FEDERAL COMMUNICATIONS COMMISSION

In re: W298AM, Aurora, FL
BPFT-20100719AAJ
Facility ID # 138466

This refers to: (1) the above-captioned application for W298AM, Aurora, Florida.

LAMBERT EQUAL AREA MAP

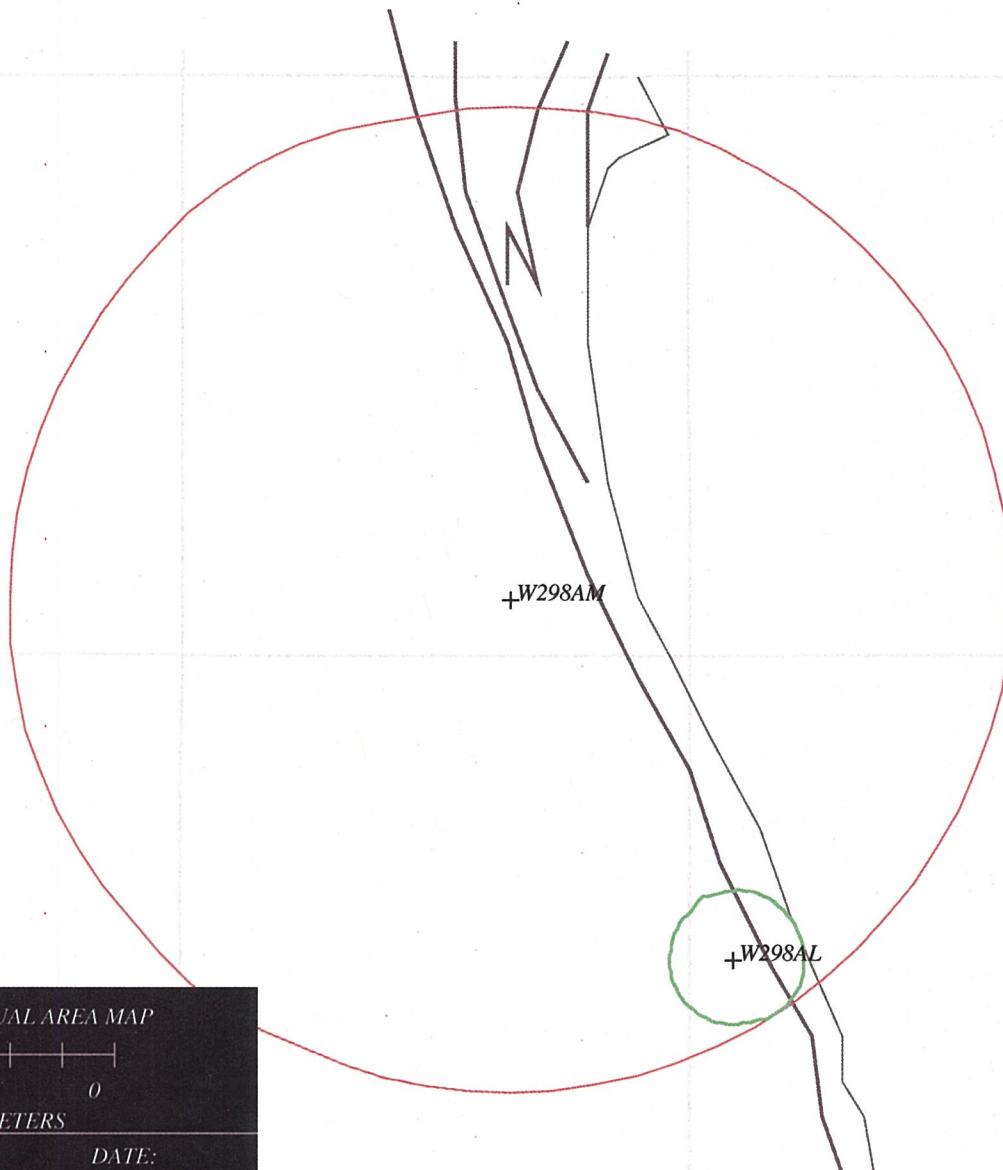
An engineering study has revealed the application violates 47 C.F.R. § 74.1204(a) with respect to W298AL, Wabasso, Florida (BLFT-20070220AAK). Section 74.1204(a) states that an application for a FM translator station will not be accepted if the proposed operation would involve prohibited overlap of predicted field strength contours with any other authorized station. The proposed 40 dBu interference contour overlaps with the 60 dBu protected contour of W298AL.

In light of the above, the application BPFT-20100719AAJ filed by Reach Communications is unacceptable for filing pursuant to 47 C.F.R. § 73.3566(a) and IS HEREBY DISMISSED. This action is taken pursuant to 47 C.F.R. § 0.283.
